FVTX Project Overview Cost & Schedule

FVTX Project Manager

2008 Annual Review Recommendations

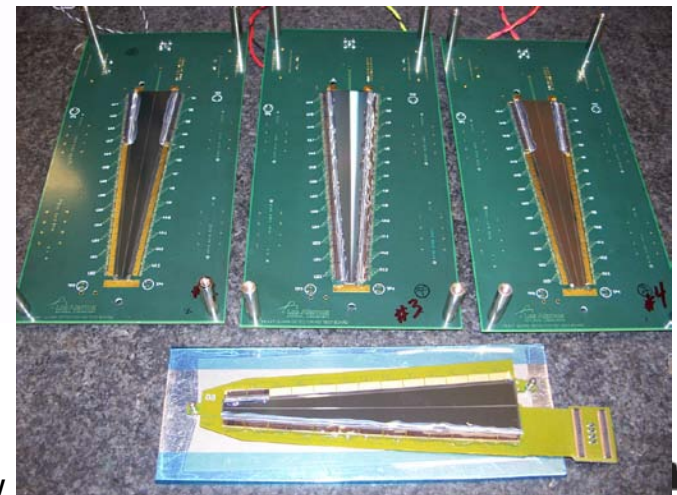
"The collaboration should design a normal printed circuit board as the first multi-chip module to test the FPHX prototype run. This should be done as soon as possible to remove the HDI as a potential schedule risk associated with the FPHX submission."

- Response:
 - PCBs made and procured
 - Delivery ~same time as kapton HDIs
 - However, simple interconnect allowed us to comprehensively test much faster than with kapton HDI

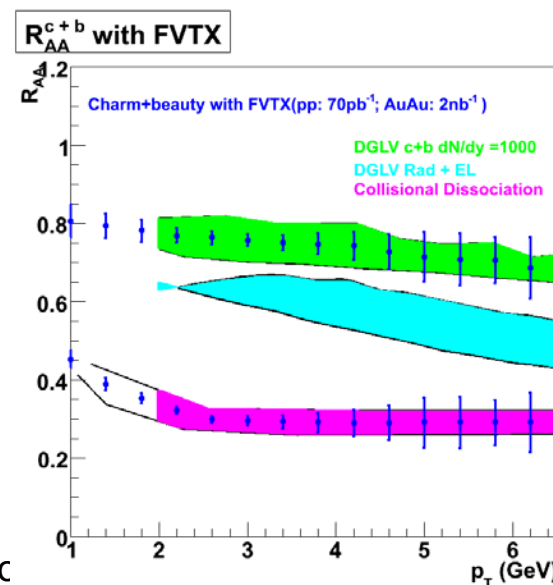
"A complete heavy flavor R_{AA} analysis chain with realistic DCA errors should be demonstrated as soon as possible, and presented with one of the quarterly reports prior to the next annual review. A list of people who are actually doing the offline software and analysis, their FTE level of support, and their time schedule, should be presented as well."

- Heavy flavor R_{AA} produced in unblind analysis previously
- Blind analysis work with updated code underway
- Full reconstruction and analysis chain developed
- Detector performance maintained
- Working on updating physics plots
- Software workers:
